Board of Trustees Regular Meeting Agenda Hartland Township Hall Tuesday, September 01, 2020 7:00 PM

Submitted By: Troy Langer, Planning Director

Subject: Site Plan Application #20-005 Hartland Senior Living PD – Preliminary Site Plan

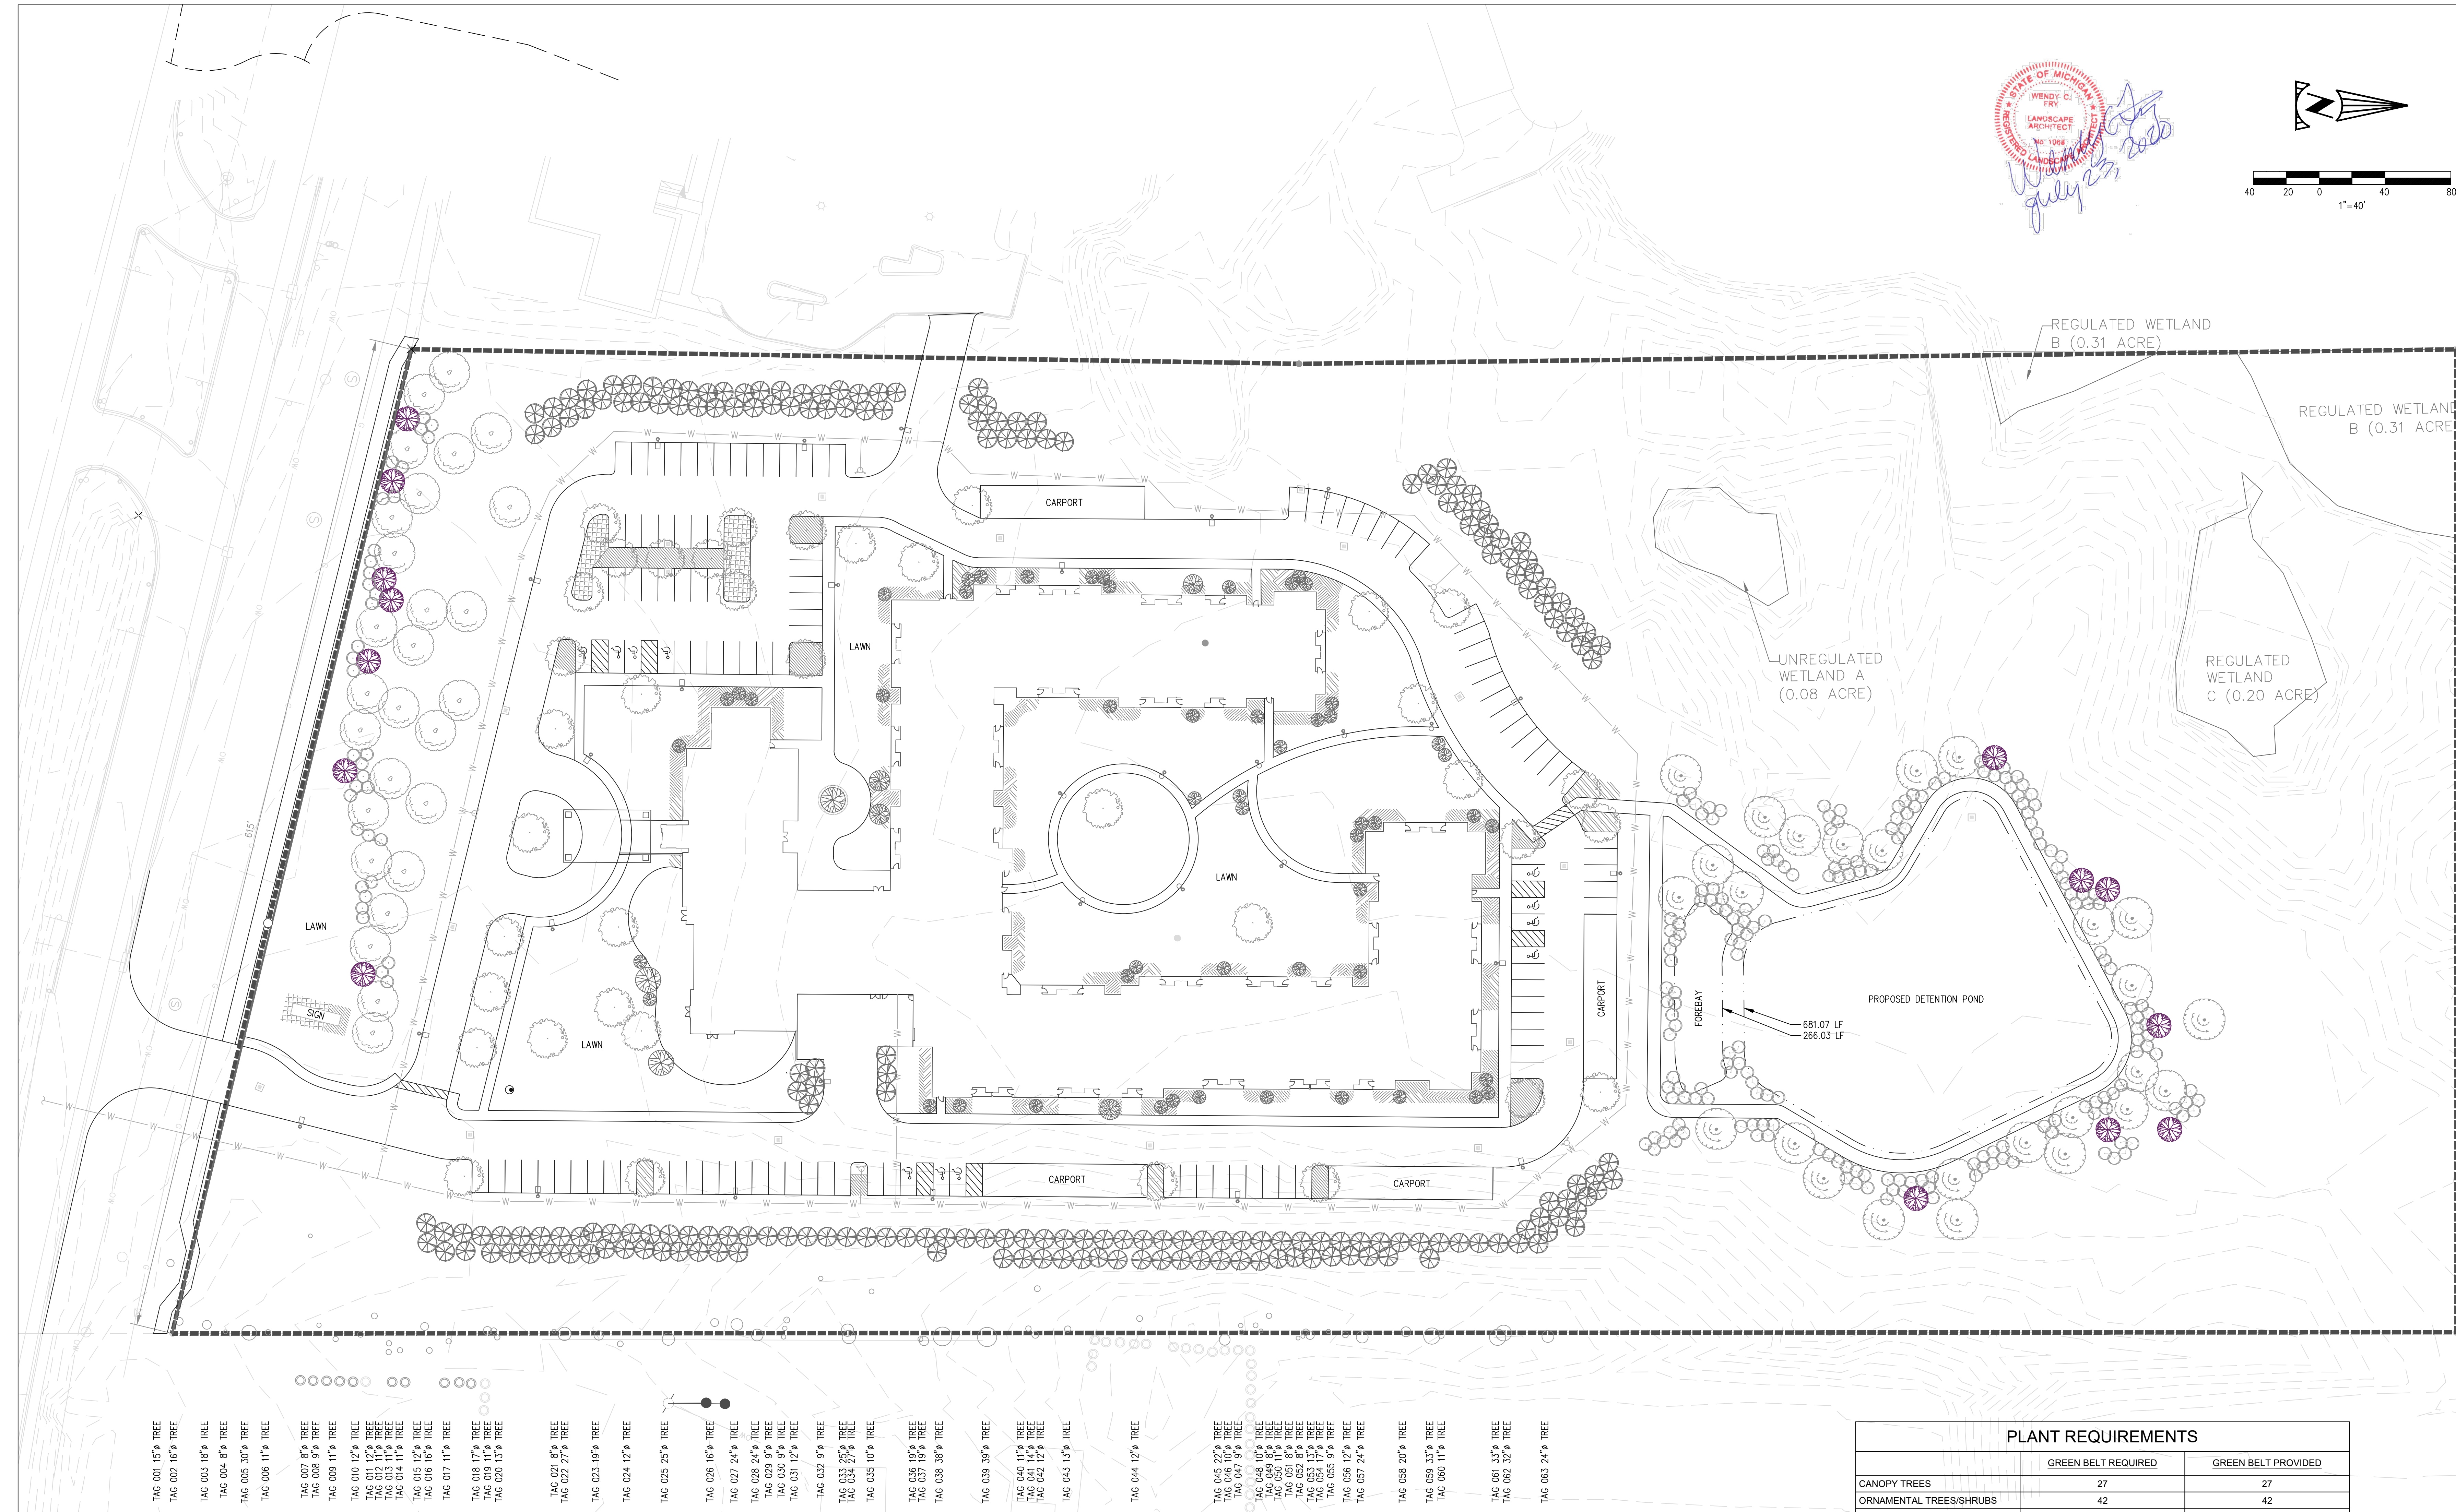
- Sheet 9 (Overall Preliminary Landscape Plan) labels several areas as “Lawn”, which are generally around the formal areas of the site, in the greenbelt, around the building and in the courtyard. Staff assumes these are mowed turf areas which should be irrigated. Other areas on the site appear to be lawn areas but are not labeled. These areas, as noted on the landscape plan provided by staff, should be labeled and the seed mix should be provided on Sheet 14 or Sheet 15. Depending on the seed mix and type of lawn, irrigation may or may not be required.

- The revisions shall be provided on the Construction Set of plans.

BUILDING ELEVATIONS

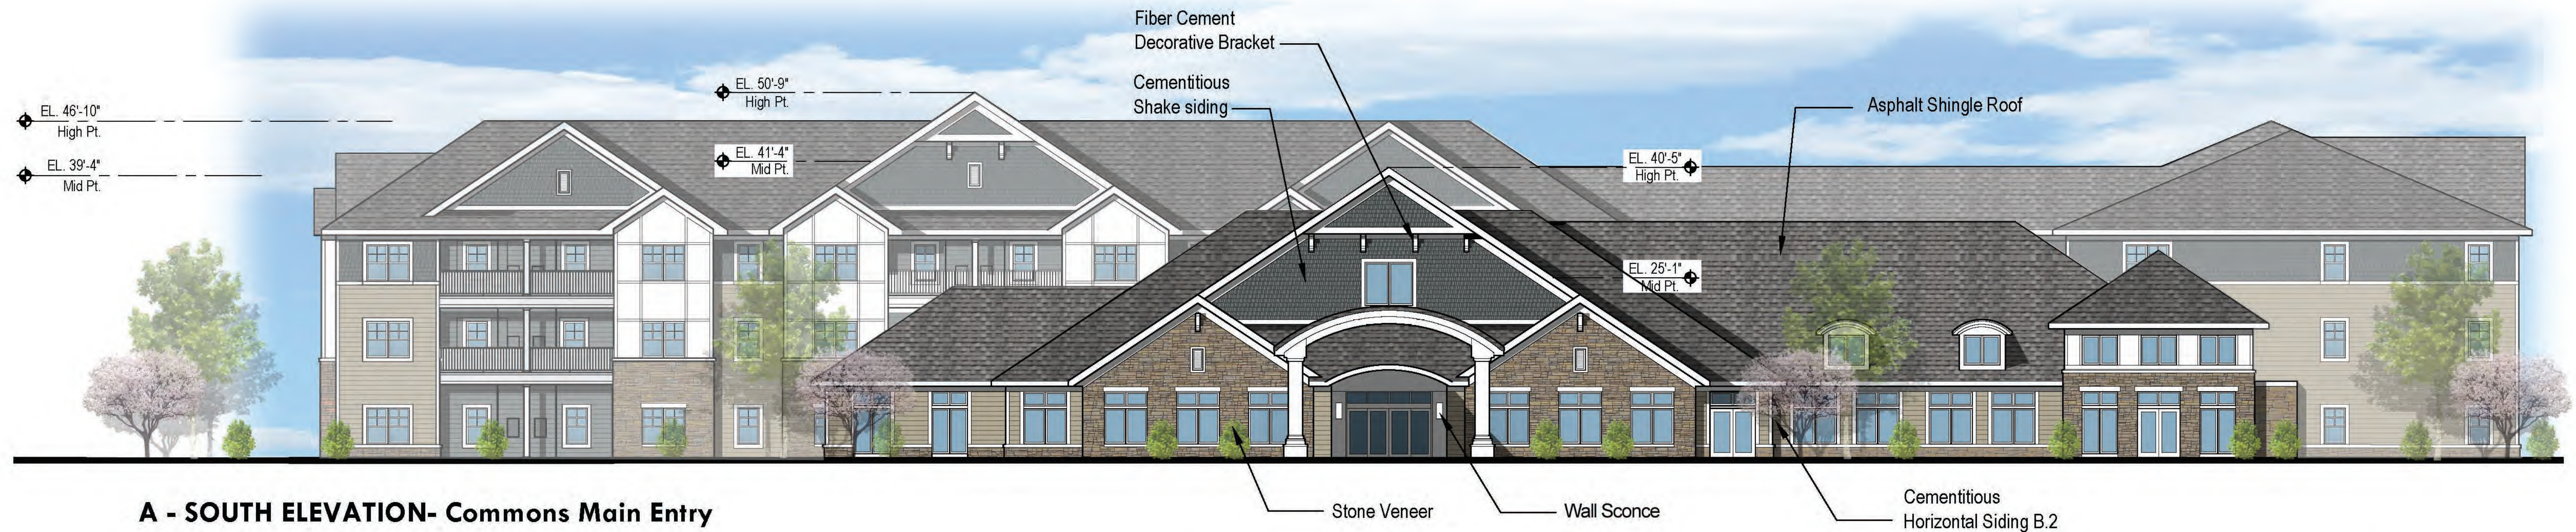
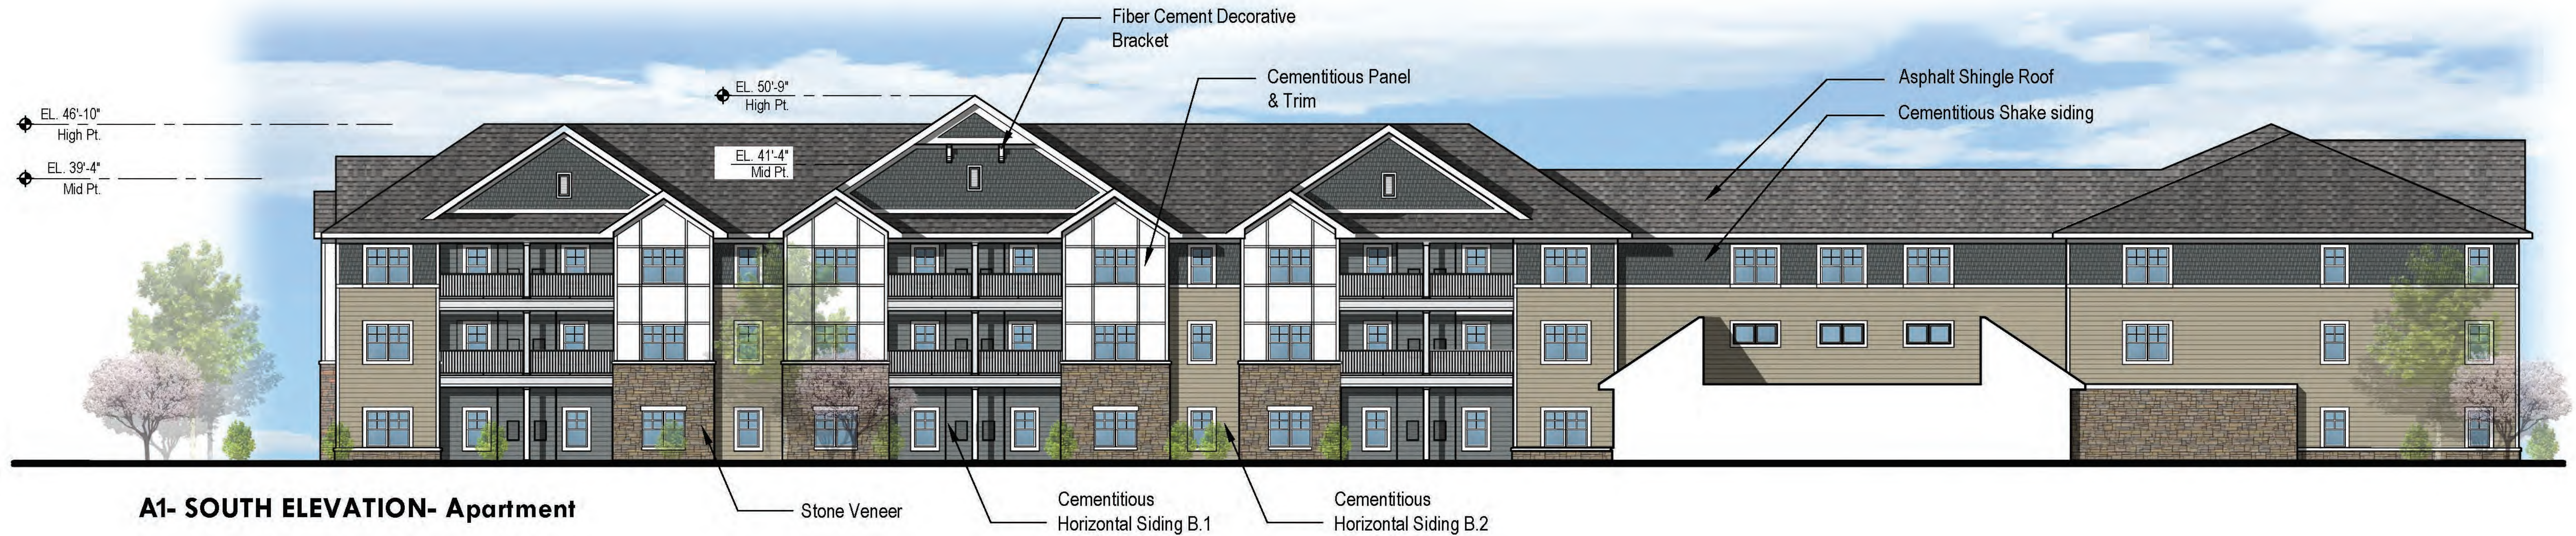
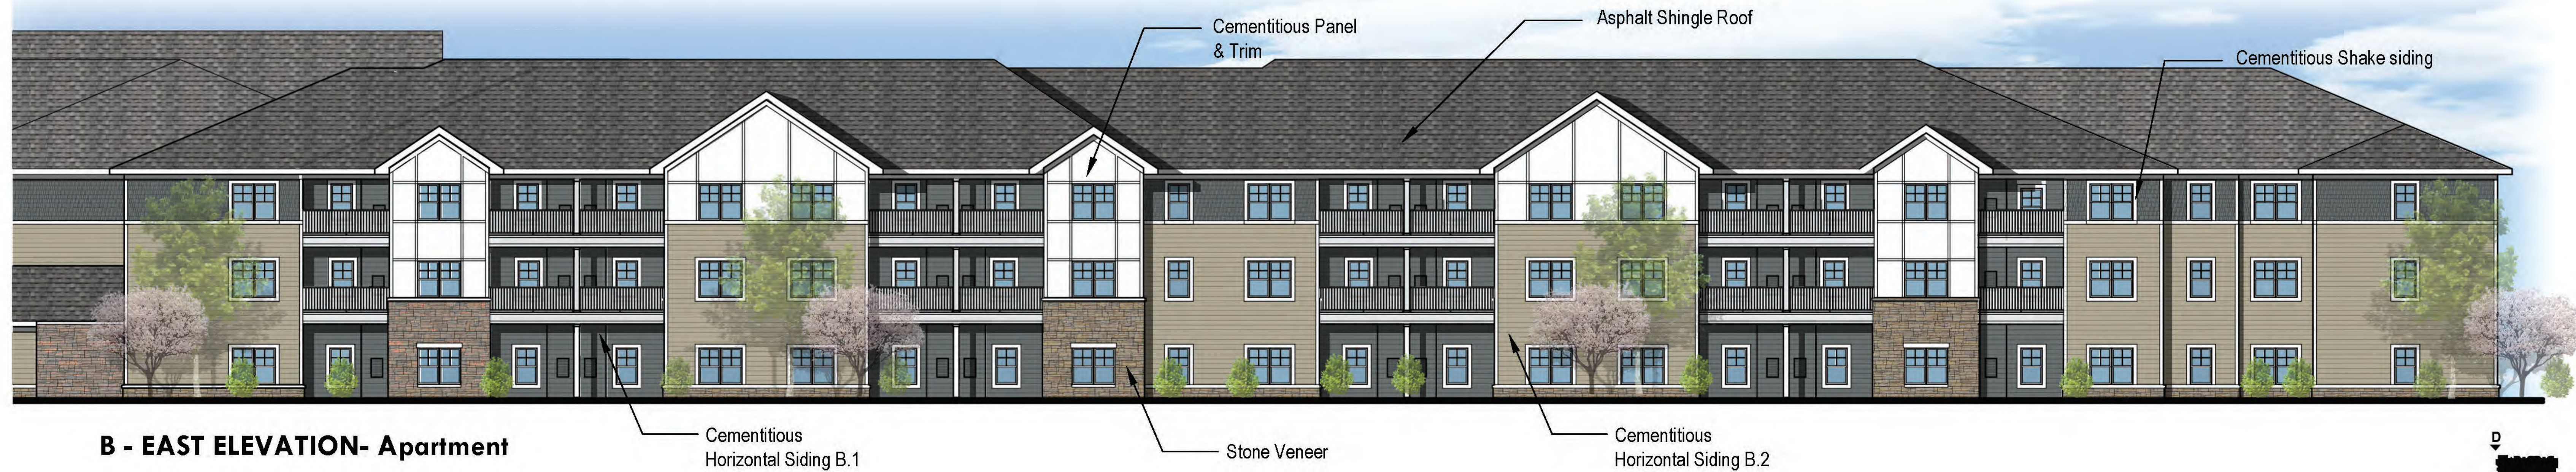
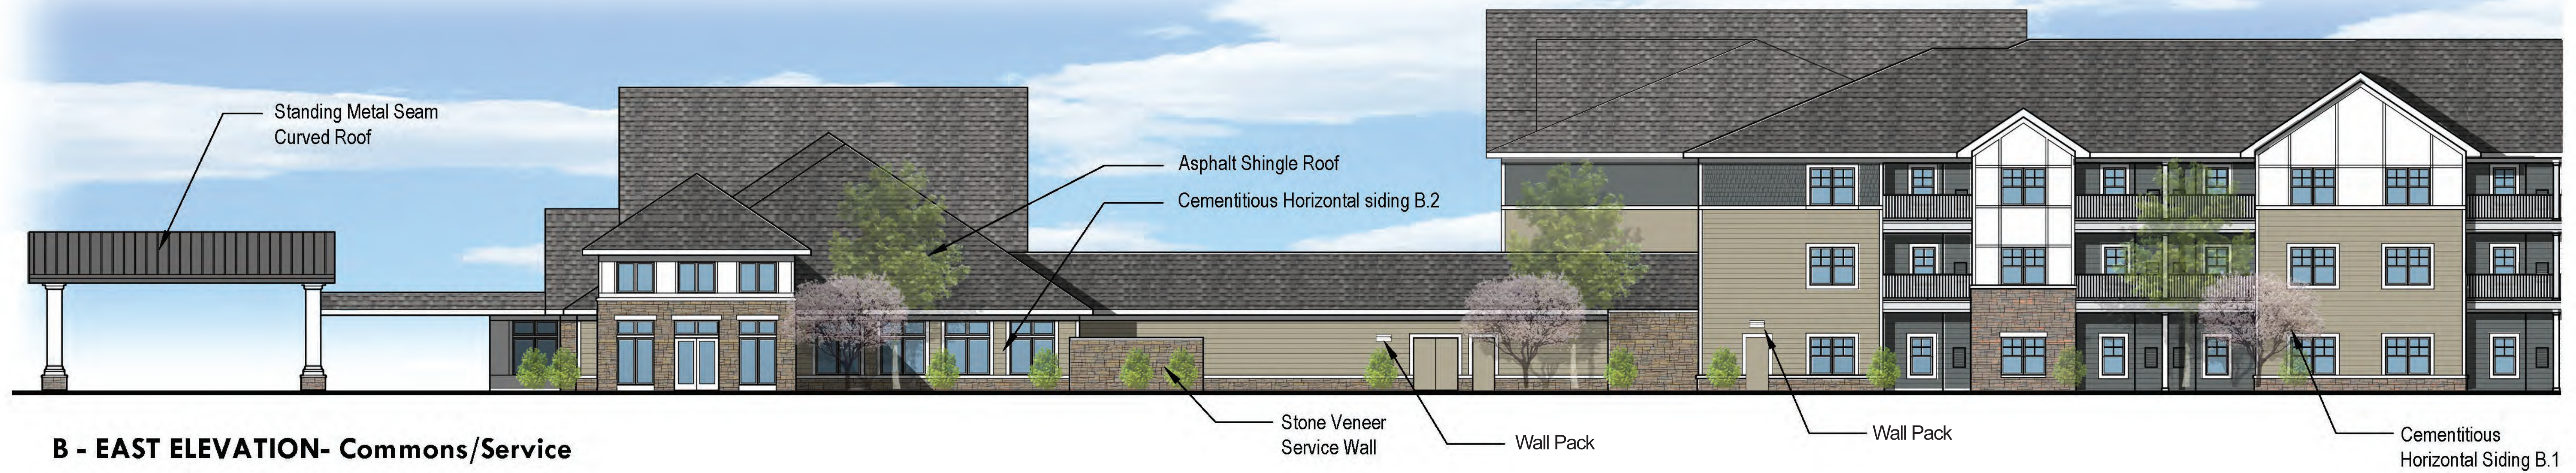
Staff would note that there appears to be inconsistencies for the data (facade material percentages) listed for building façade labeled as “A1” (south elevation for apartment building) in the chart on Sheet A-7 and Sheet A-12. Staff reached out to the applicant about this however the applicant did not confirm which chart has the correct information before the completion of this memorandum. This needs to be clarified on the Construction Set of plans. For purposes of this analysis, staff used the data found on Sheet A-12 for building façade “A1”.

- Meets Requirement? – **TBD**
- Comment – The applicant has submitted an architectural waiver request, dated July 22, 2020, to deviate from the maximum allowable and minimum required façade material percentages, as follows: cement board siding exceeds 10% on all elevations; fiberglass shingles exceed maximum of 25% on most elevations; standing seam metal roof exceeds 20%; and brick is not utilized (30% minimum is required). The applicant’s waiver request is to exceed the 10% maximum for cement board siding. Staff assumes that this is for each type of cement board siding (B1 and B2). Other cement board products are also used (shakes and panels) which are not specifically listed as a façade material in Section 5.24, thus minimum/maximum percentages are not provided. A sum total of all cement board products is provided for each elevation in the charts above.
